SMP-30 REVISED USE PERMIT SUNOL VALLEY AGGREGATE QUARRY PROJECT

RESPONSE TO COMMENTS / FINAL ENVIRONMENTAL IMPACT REPORT

SCH No. 2011102051

JUNE, 2012

SUV Traveling South on Calaveras Road at San Antonio Creek Bridge

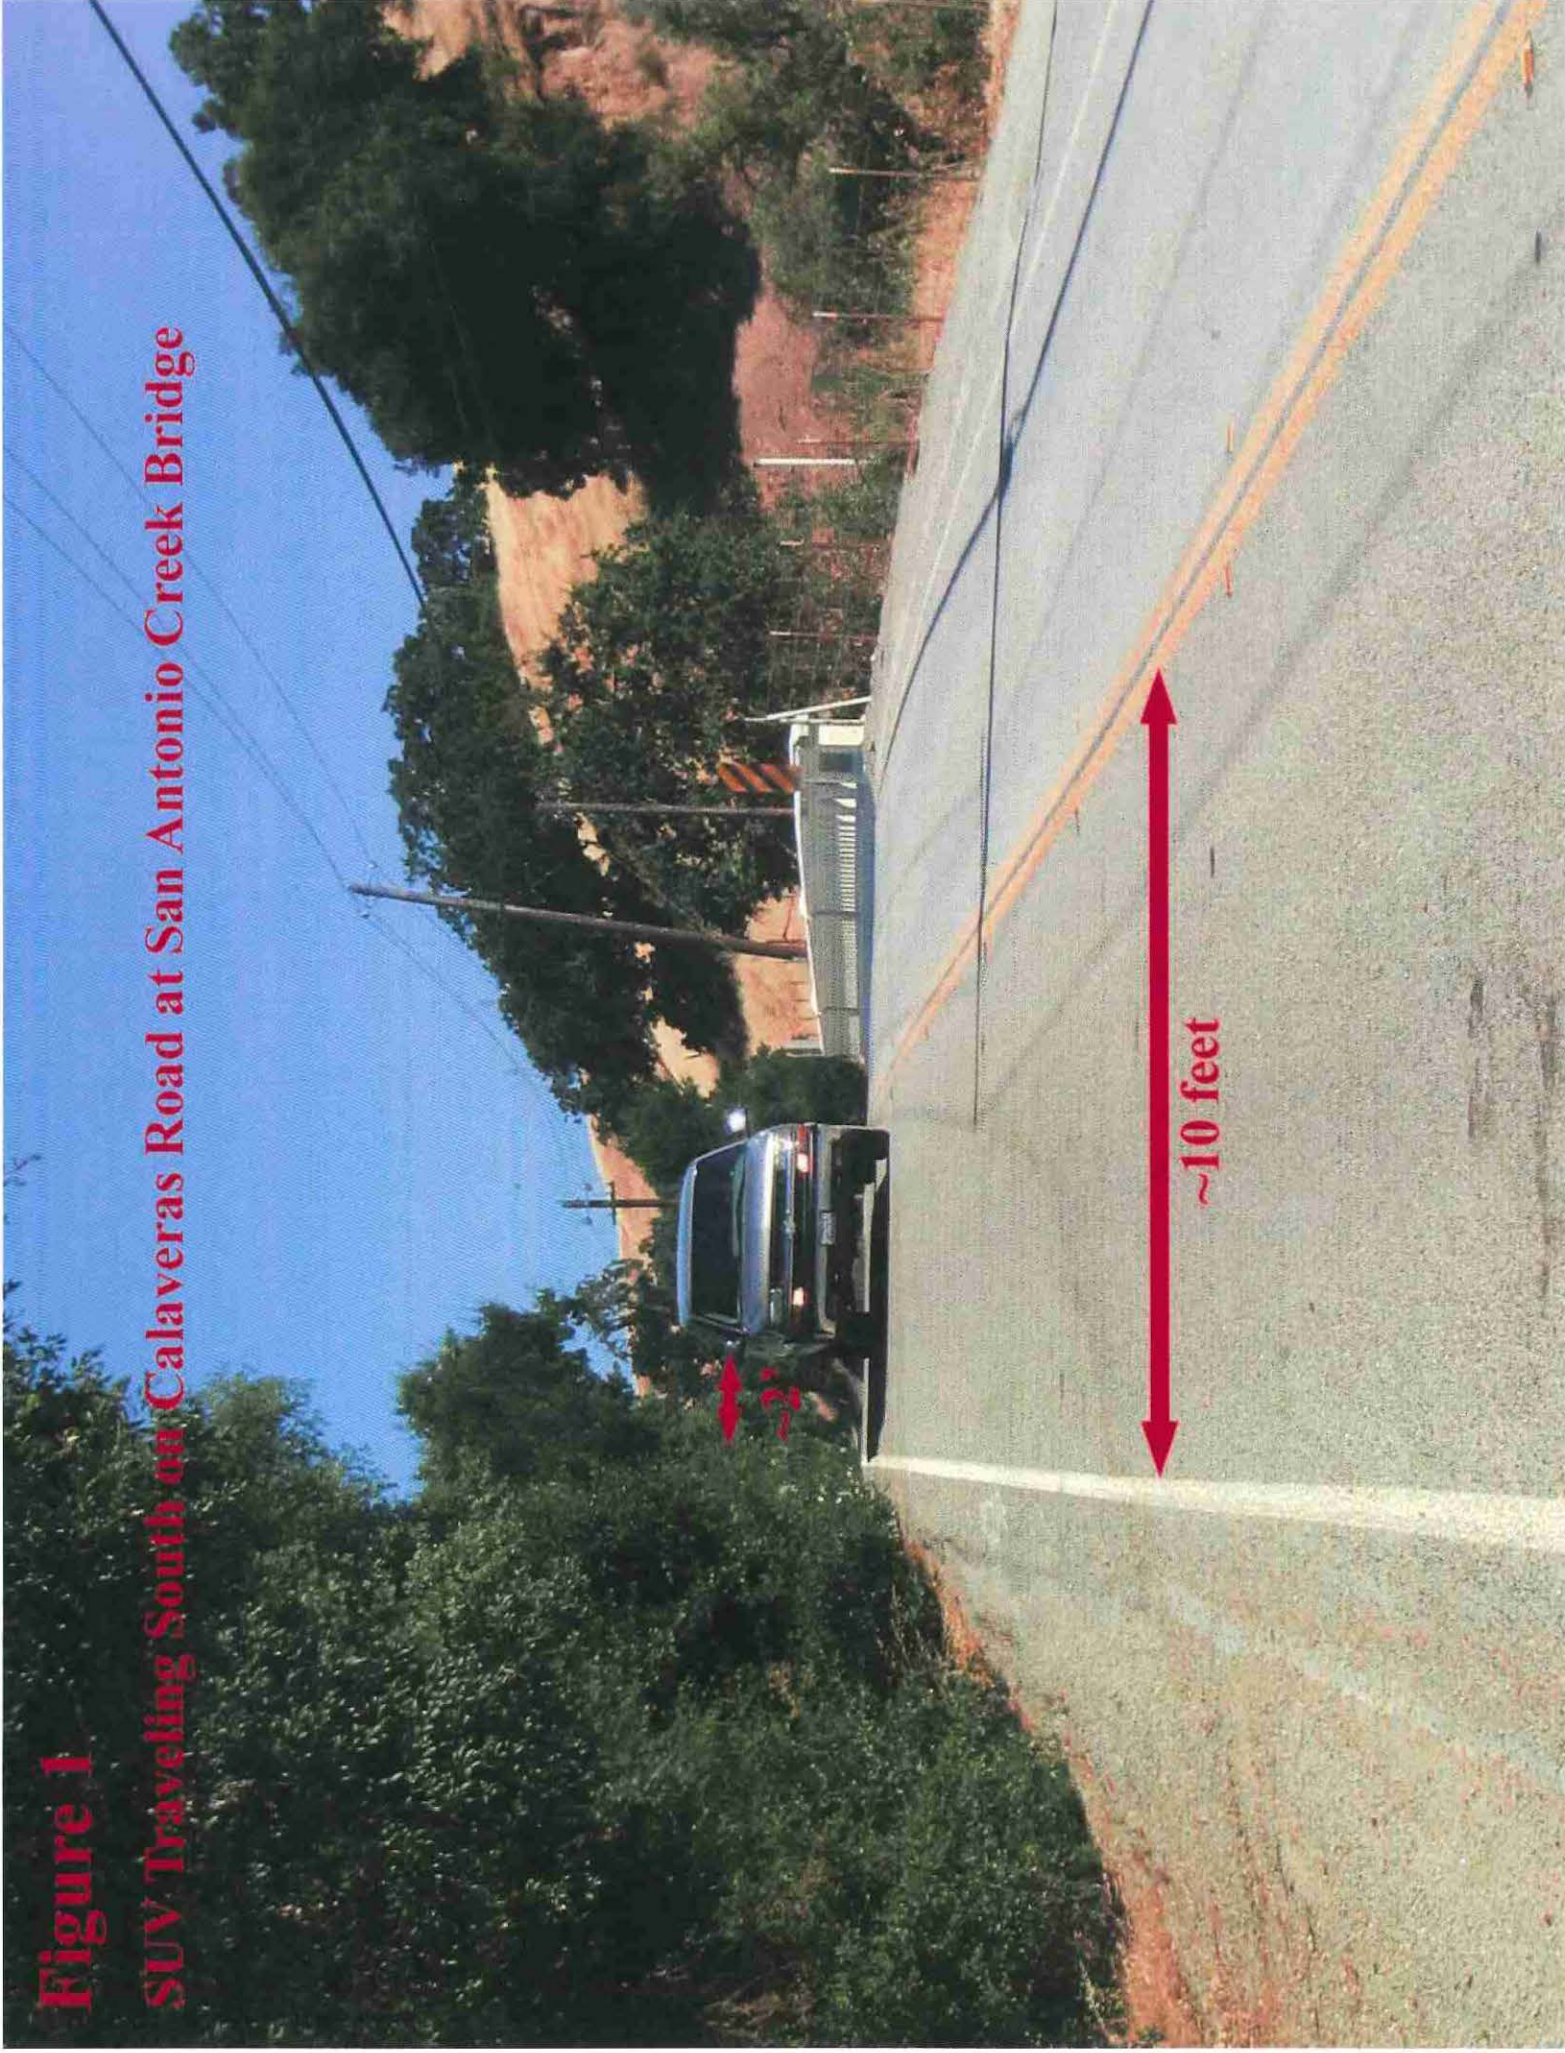
Figure 1 shows a SUV driving south on Calaveras Road. The approximate two foot distance between the SUV's side mirror and the adjacent vegetation is clearly inadequate and unsafe for bicyclists and pedestrians. Figure 2 shows that bicyclists hugging the shoulder of Calaveras Road. They cannot ride closer to the shoulder due to overgrown vegetation, gravel and steep

embankments. When the SUV in Figure 1 passed the bicyclists in Figure 2 the SUV had to straddle the center line to pass. Clearly the existing situation is unsafe for motor vehicles and bicyclists traveling in both directions. As a result of the proposed project there will be a substantial increase in traffic on Calaveras Road. This will make the present conditions substantially more unsafe. We believe this is a significant adverse effect that requires mitigation as part of the proposed project.

**Final EIR Figure 3-1
View of Sunol Valley from Maguire Peak Loop Trail**

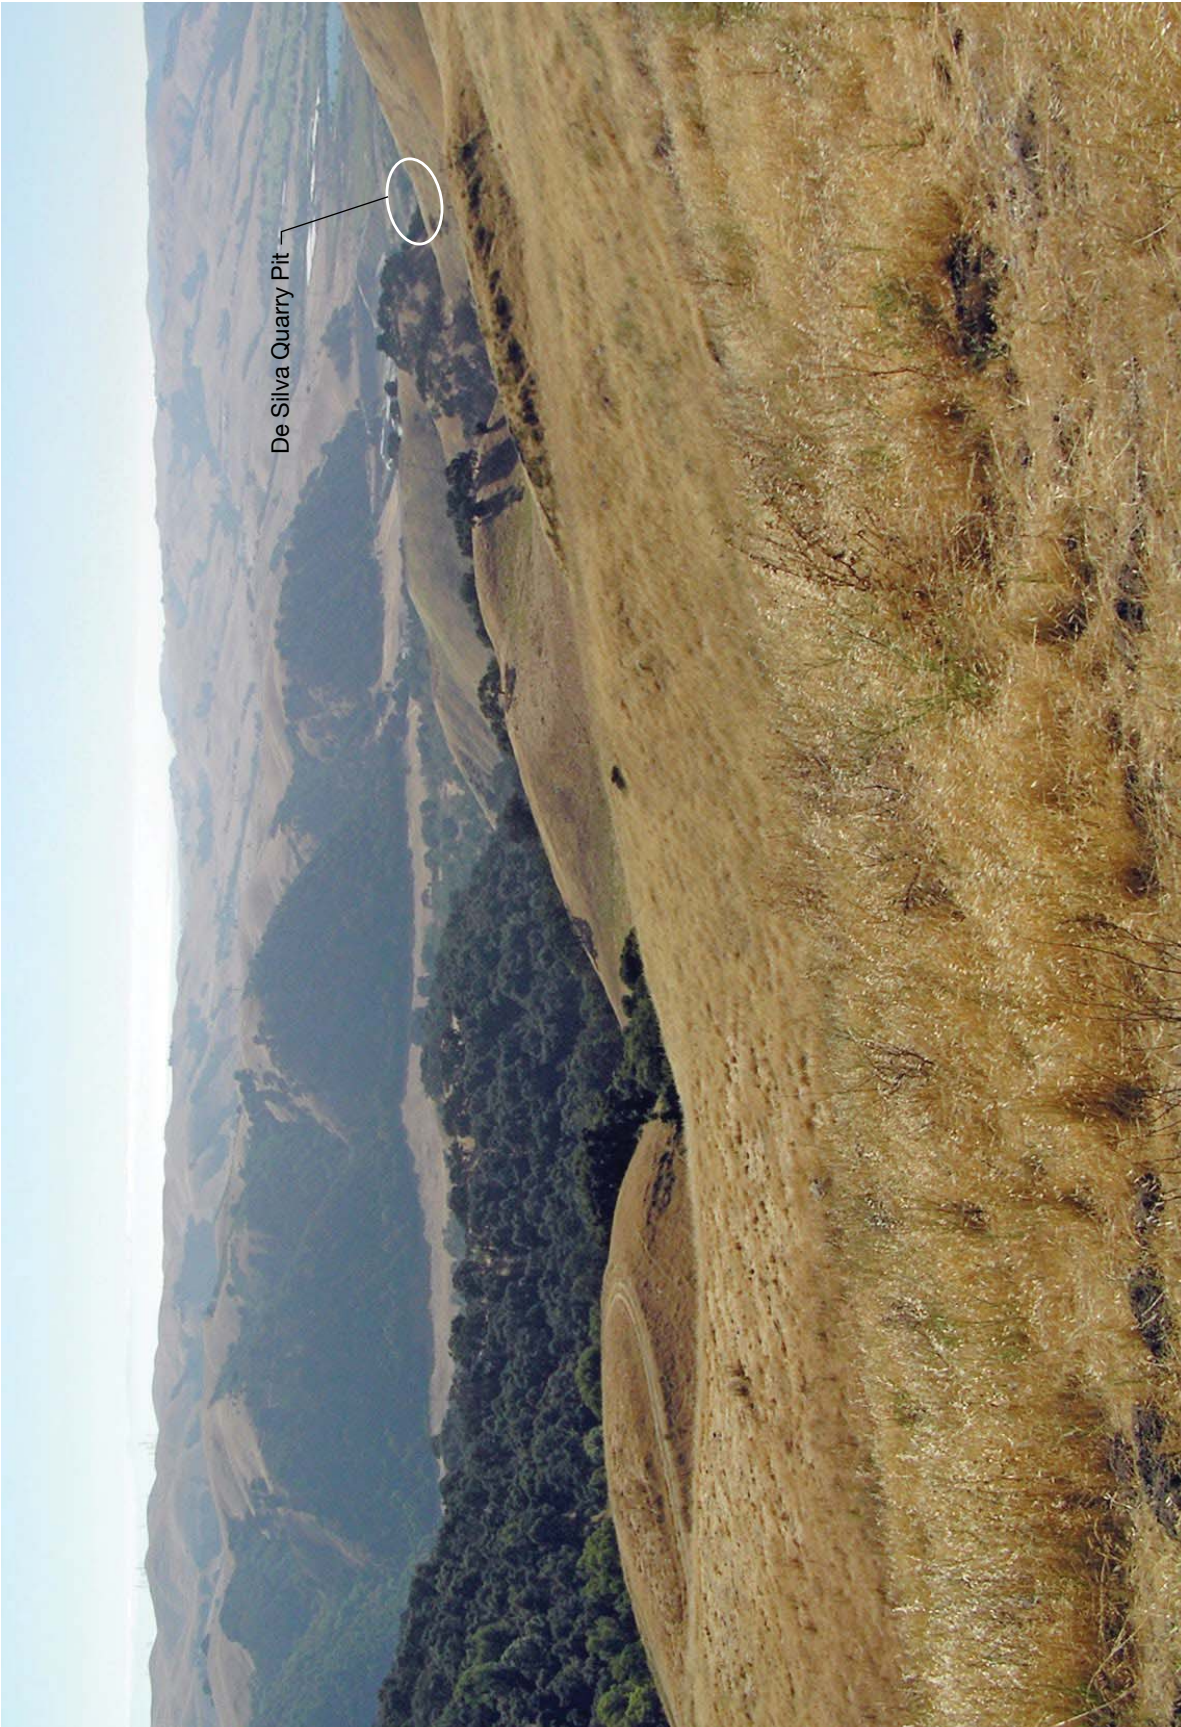
This comment points out that the Sunol Valley is located within the viewshed of several regional parks, specifically noting views from Maguire Peaks, but also including a computer-generated view from Flag Hill. Both of these viewpoints are located in the Sunol Regional Wilderness). It notes that the Project will involve construction of new structures up to 100 feet tall, will discharge plumes of steam, increase lighting, remove vegetation, grade a 58-acre expansion area and may also require new electrical transmission lines and appurtenant structures. This comment states that, with the exception of views from Pleasanton Ridge, the Draft EIR provides no visual simulations from other regional parks to support its

conclusion that the proposed Project will not result in adverse effects to scenic vistas and should provide additional visual simulations to substantiate these conclusions.

The County recognizes that the Sunol Valley and the Project site are visible from many publically accessible vantage points surrounding the valley, especially from public trails that are within regional parks and open spaces throughout the surrounding ridgelines and hillsides. Because the site is visible from so many locations, the EIR preparers collaborated with County staff to identify a number of locations from which views of the site can be seen and that were considered representative of other similar views. The five viewpoints presented in the Draft EIR included one from the Pleasanton Ridge Regional Park, two from the I-680 scenic highway and two from the adjacent Calaveras Road.

Specific to Maguire Peak, the SFPUC published a Draft EIR for the San Antonio Backup Pipeline Project in January 2012. That Draft EIR included a photograph taken from the Maguire Peaks Loop Trail looking northwest, towards the Project site (see **Figure 3-1**). It concluded that, “The Maguire Peaks Loop Trail, located approximately 1.2 miles southeast of [that] project site and within the Sunol Regional Wilderness, is the nearest recreational trail to that project area [and similarly the nearest trail to the SMP-30 Project site]. The trail offers views of the Sunol Valley, including the southern portion of [that] project area and quarry pit F6 (the SMP-30 Project’s South Basin, or main quarry pit). Although the quarry pits operated under SMP-30 are partially visible, the project area is largely obscured by intervening topography. Since views are relatively distant and intervening topography obstructs views of the project area, viewer sensitivity from the Sunol Regional Wilderness is considered low.” The County concurs with this conclusion from the SFPUC’s Draft EIR and believes that this conclusion further supports this EIR’s conclusion that, although implementation of the Project would change existing views of the Project site from surrounding vantage points, the Project would not substantially adversely affect these scenic vistas.

Revised Figure 3-1
Project Site Location

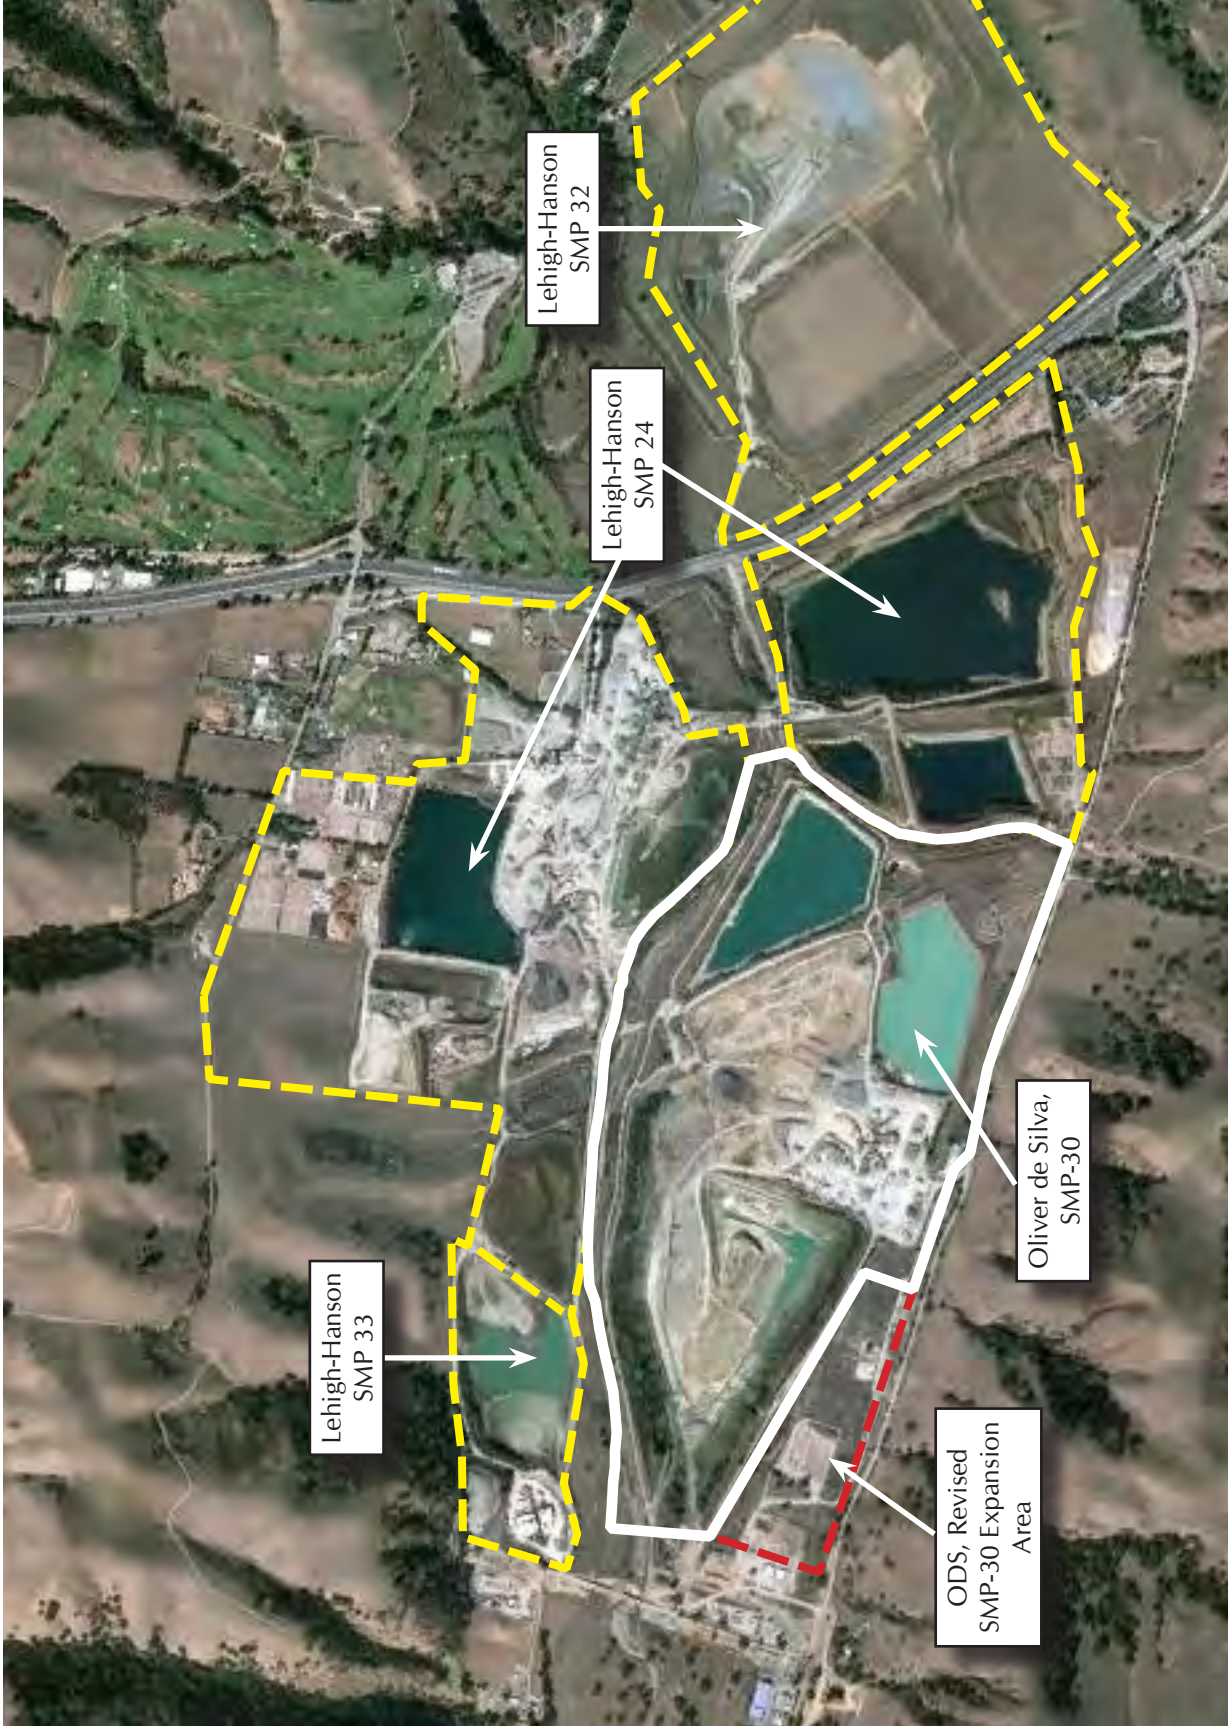
Figure 1-2, project site location (see also Figures 3-1, 3-4, 3-6, 6-2), shows pit F3 West as within boundary of SMP 30; figures should be revised to be consistent with the text on page 3-1 that accurately describes the Project location as "... bounded by San Antonio Creek to the north, Alameda Creek to the west and Calaveras Road frontage to the east." (Note Figure 3-2, Assessor's parcel map, and Figure 3-5, the original SMP 30 mining area drawing, both appear to show the inclusion of land on the far side of San Antonio Creek, which was moved as part of that approval and is not part of SMP-30..

Figure 5-3: Names of mining operators in figure (e.g. "RMC Materials", "Mission Valley Rock") should be updated to match current operators.

Alameda County appreciates the clarifications of the Revised SMP-30 permit boundaries. Please see **Figure 4-1** in the Errata chapter of this Final EIR, which replaces and supersedes Figure 3-1 of the Draft EIR. Other figures included throughout the Draft EIR were also prepared using a Project site boundary that is consistent with Figure 3-1 of the Draft EIR, but which are no longer accurate. Pursuant to this response, all Project boundaries as shown in the Draft EIR are intended to be approximate, with the boundaries shown on Figure 4-1 of the Errata chapter of this Final EIR as prevailing. These minor changes in Project boundaries do not affect the environmental analysis as presented in the EIR. Similarly, neither these changes in the Project boundaries nor the boundaries of any existing or presumed subsequent lease agreements result in a subdivision or split of existing parcels or reduce parcel sizes below the 100-acre minimum parcel size required pursuant to the County General Plan (Measure D).

Comment noted, please see revised Figure 5-3 as presented in Chapter 4: Errata of this Final EIR.
